Project	IEEE 802.16 Broadband Wireless Access Working Group < http://ieee802.org/16 >	
Title	Normal MAP Extension for H-ARQ	
Date Submitted	2005-01-24	
Source(s)	Yigal Eliaspur, Yuval Lomnitz, Zivan Ori Intel Corp.	yigal.eliapsur@intel.com , yuval.lomnitz@intel.com , zivan.ori@intel.com
	Geunhwi Lim, Jiho Jang, Wonil Roh, Yong Chang, Seungju Maeng Samsung Electronics Co. Ltd.	geunhwi.lim@samsung.com , yongchang@samsung.com
Re:	IEEE P802.16e/D5a	
Abstract	The document contains suggestions for extending the Normal MAP for H-ARQ support. Additionally, certain MAC fixes are described for H-ARQ support.	
Purpose	Adoption of proposed changes into P802.16e /D5a-2004	
Notice	This document has been prepared to assist IEEE 802.16. It is offered as a basis for discussion and is not binding on the contributing individual(s) or organization(s). The material in this document is subject to change in form and content after further study. The contributor(s) reserve(s) the right to add, amend or withdraw material contained herein.

Figure 23a Sub-MAP Burst

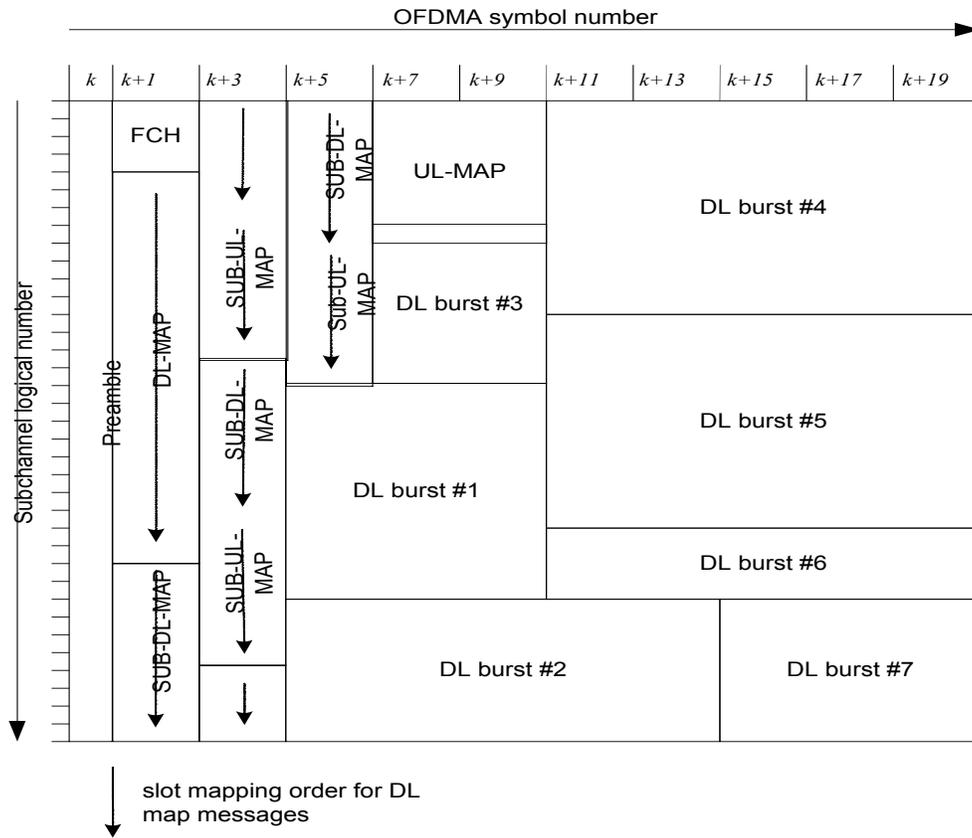
[Add new section 6.3.2.3.59]

6.3.2.3.59 Sub downlink/uplink map (SUB-DL-UL-MAP) message
